Administrative Amendment for City of Albuquerque permit #BP-2020-27106

Re: McDonald's 4300 Osuna Rd. NE (PR 2020-004189)

RE: Amendment to Site Development Plan
McDonald's Restaurant – 4300 Osuna Rd. NE

CITY DETAILS
C7.5

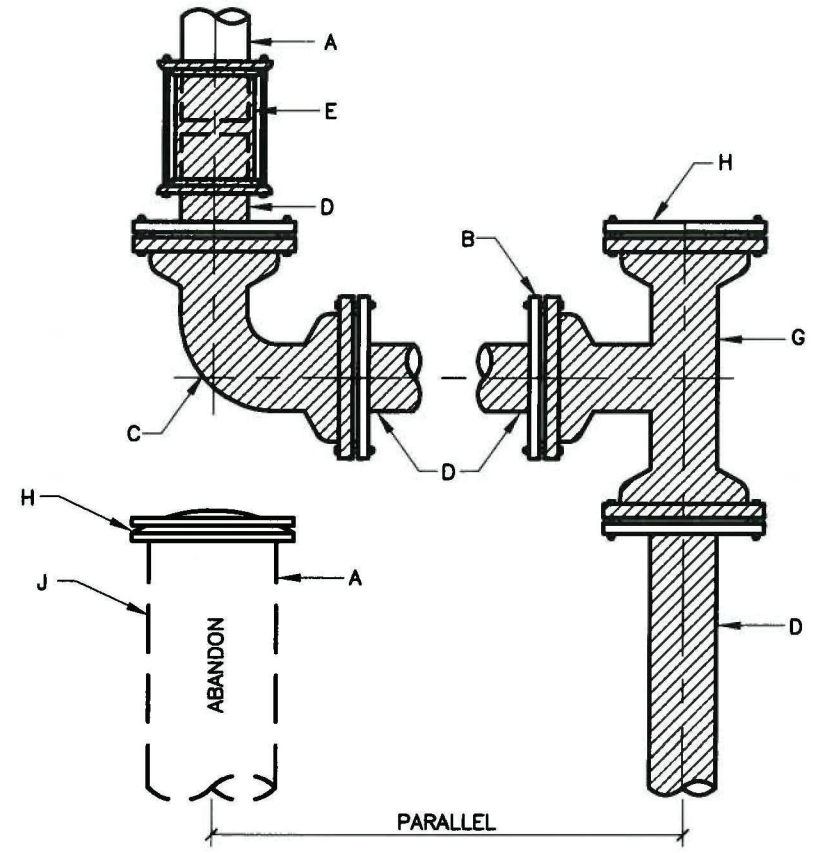
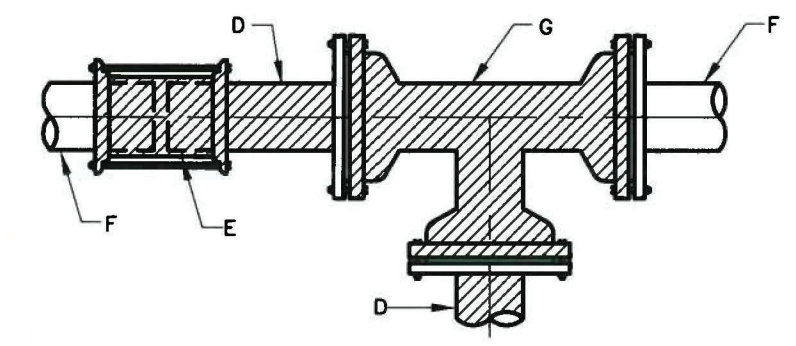
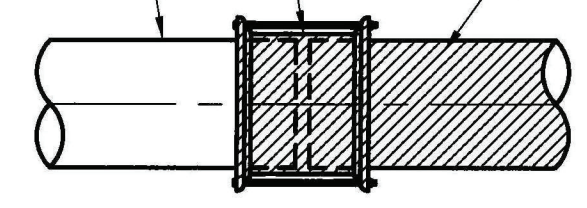
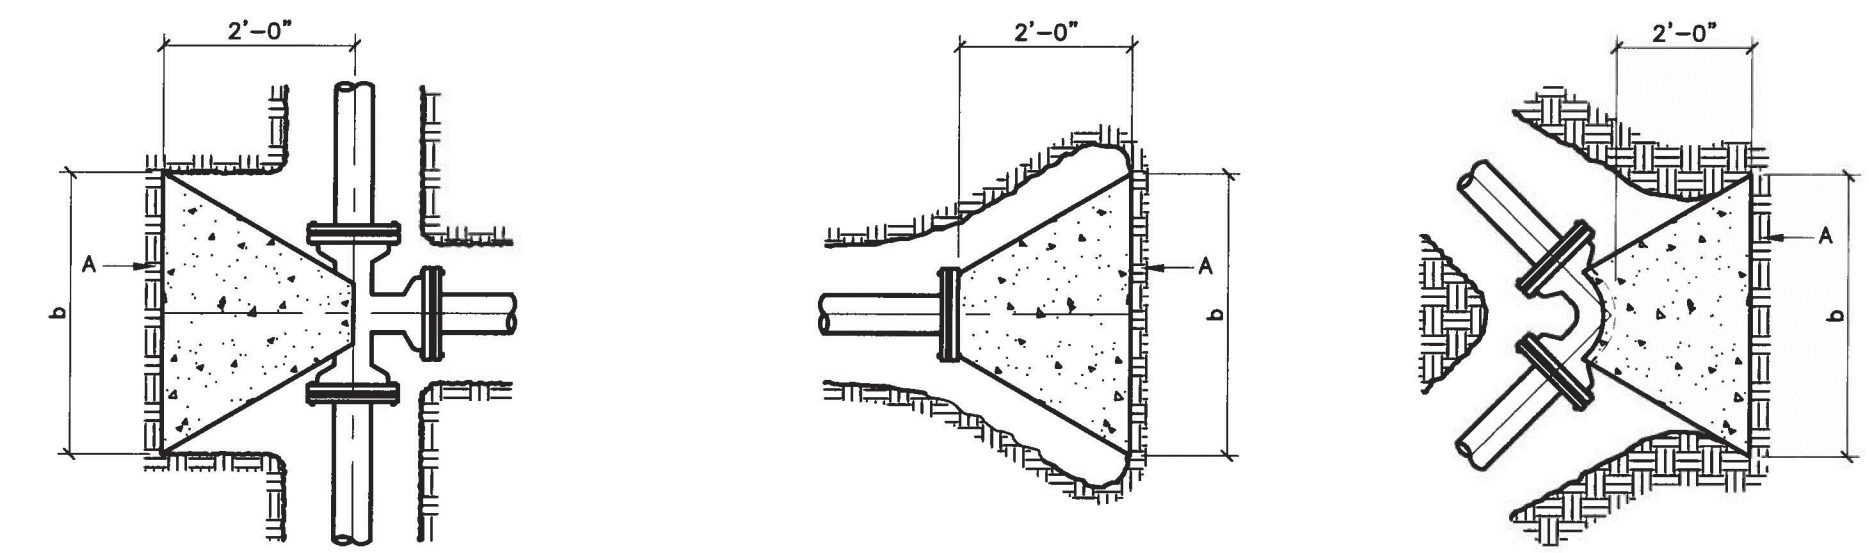
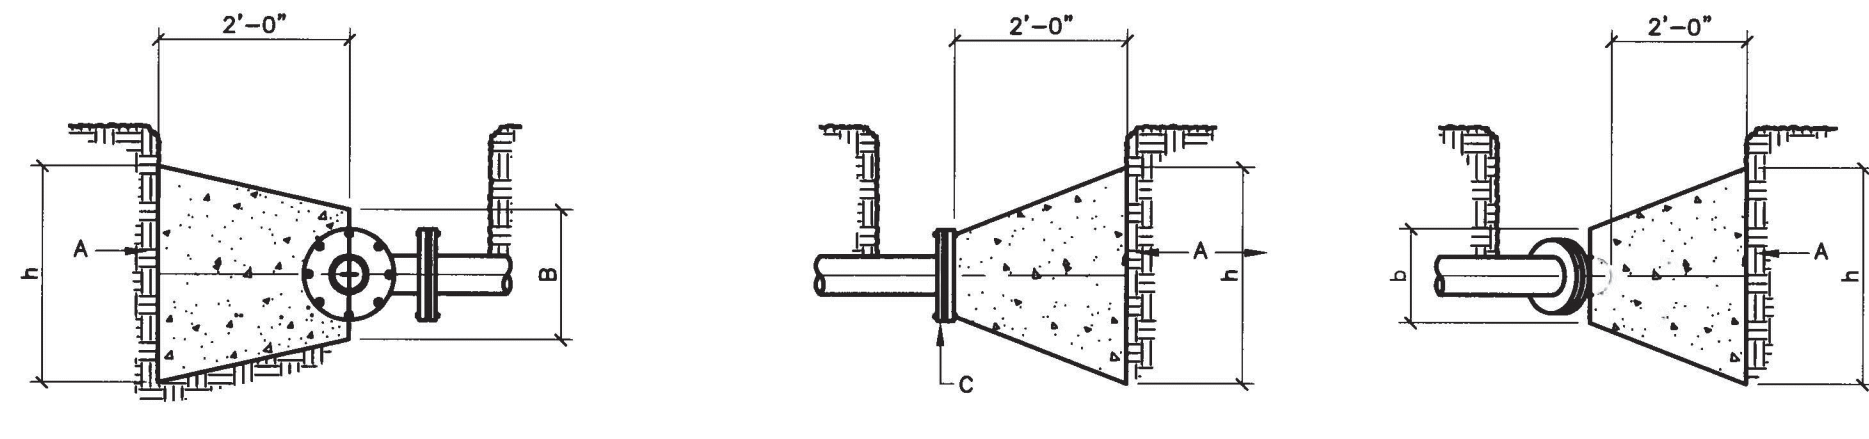
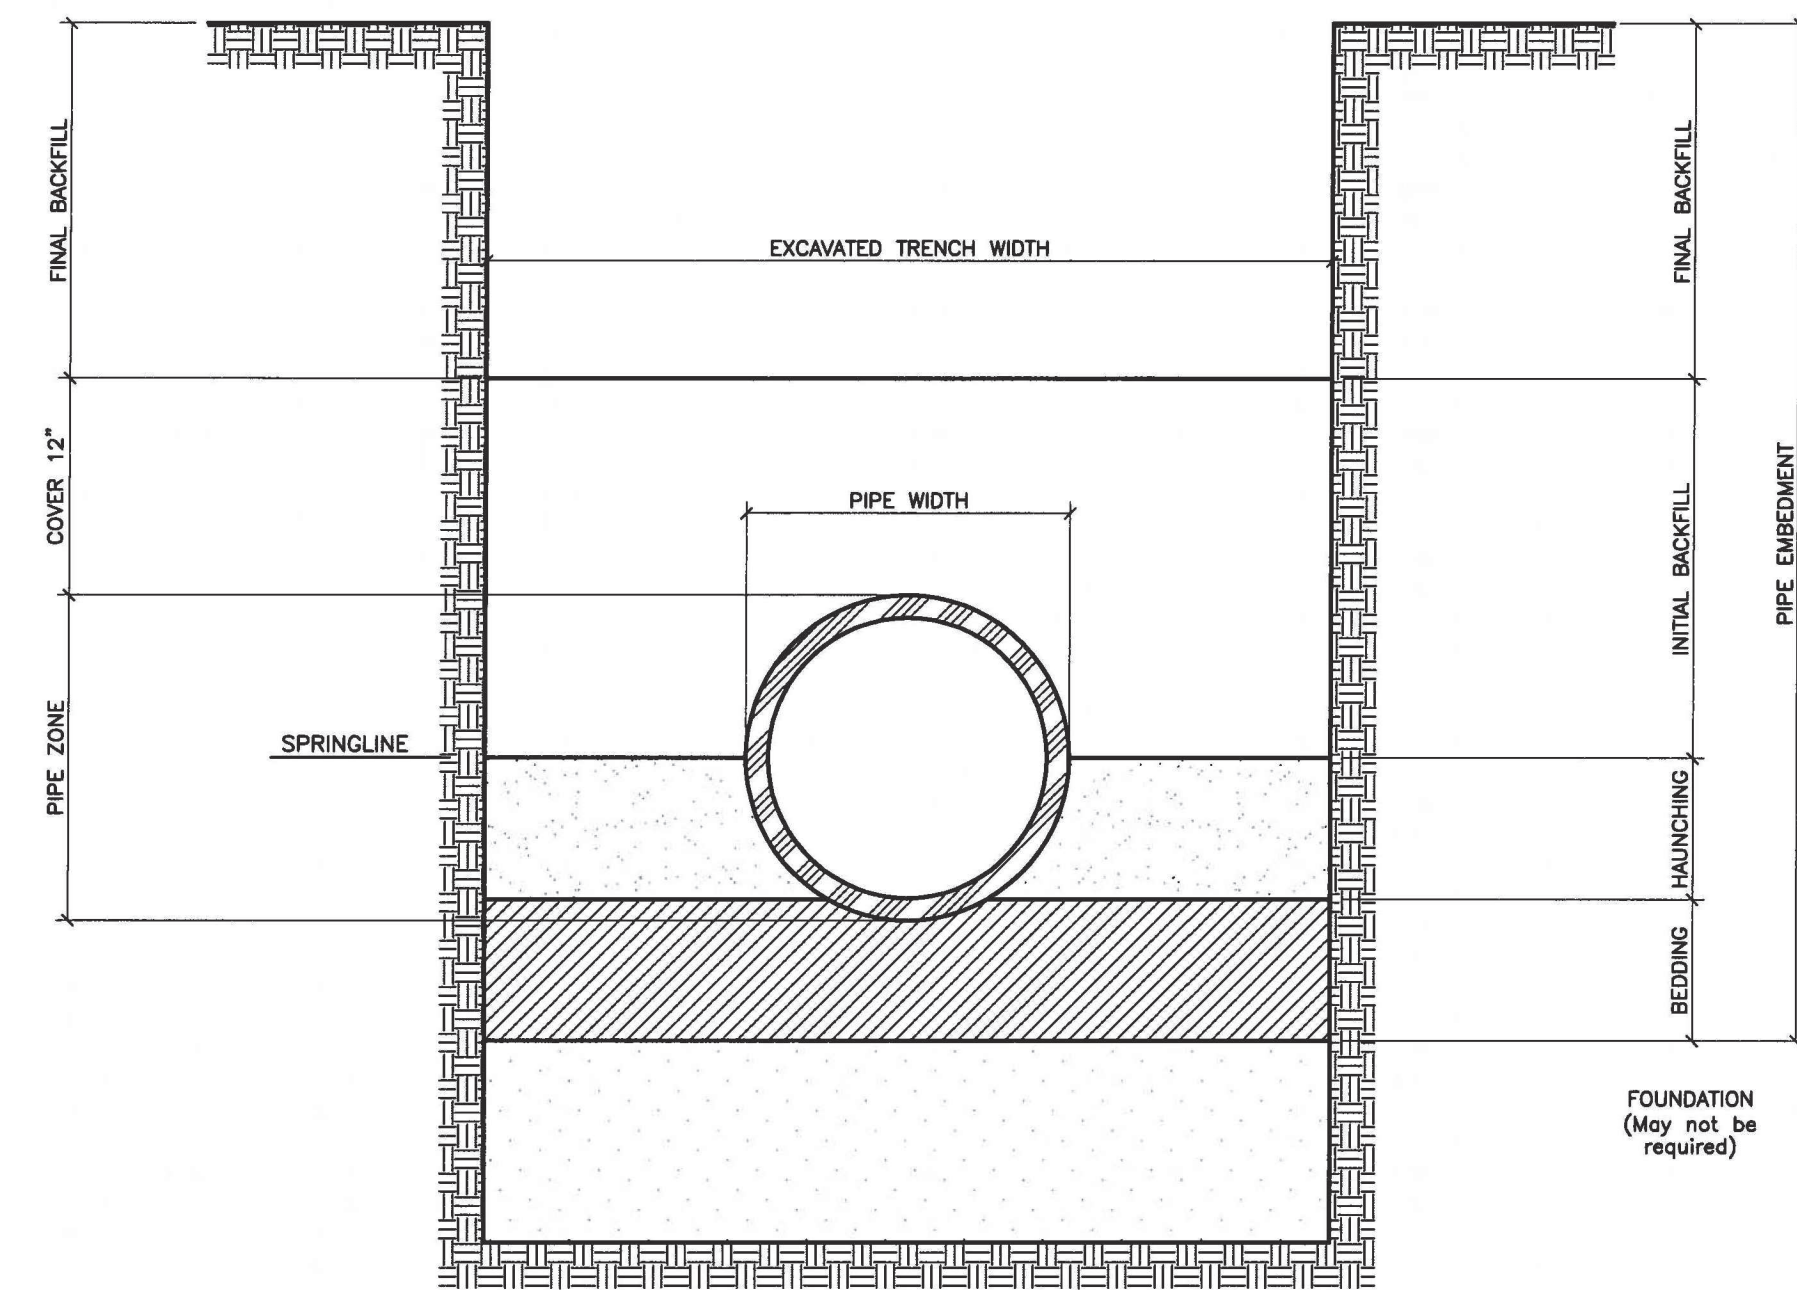
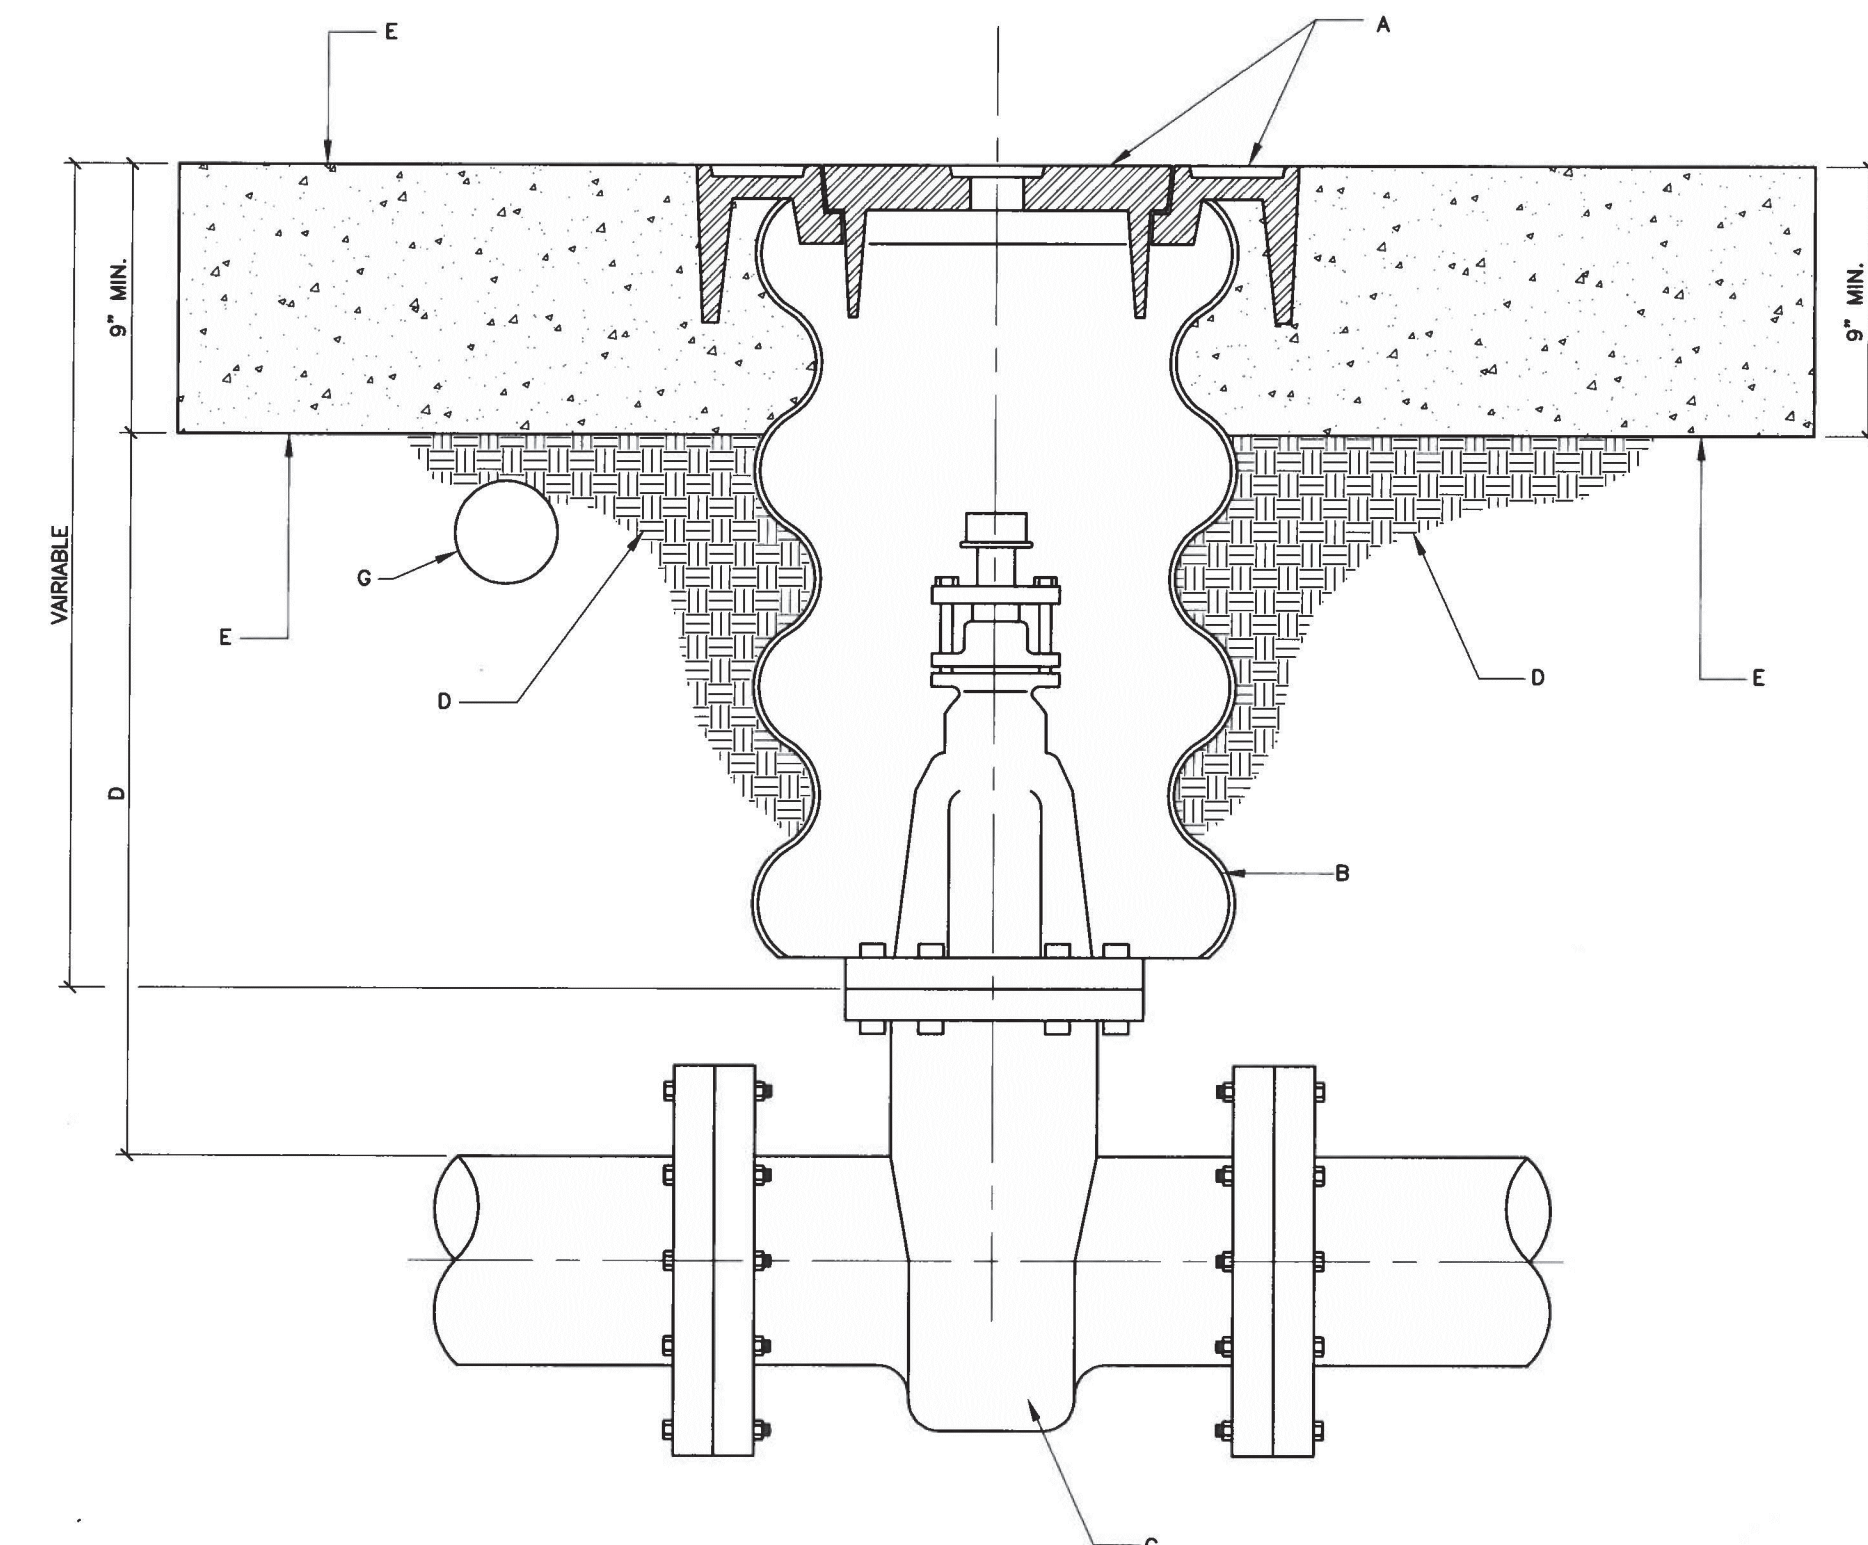
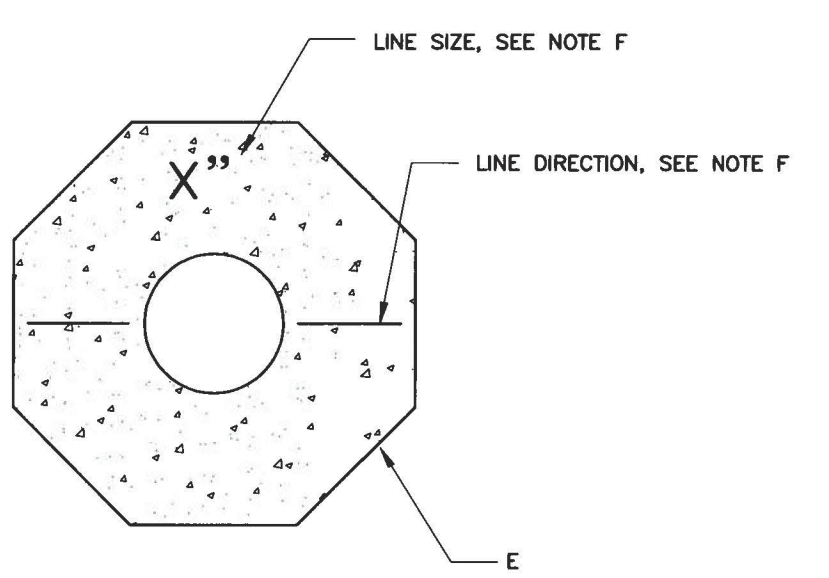
- An 11' wide van accessible space with a 5' aisle are shown in accordance with ADA Standards 502.2 and 502.3.1. See C3.0 Site & Paving Plan.
5. Include C7.1, C7.3 and C7.5 standard details as part of this set. All details for curb, sidewalk, curb ramps, and signage have to be included.

- Detail sheets have been included.
6. The ADA accessible parking sign must have the required language per 66-7-352.4C NMSA 1978 **"Violators Are Subject to a Fine and/or Towing."** Provide detail of sign.
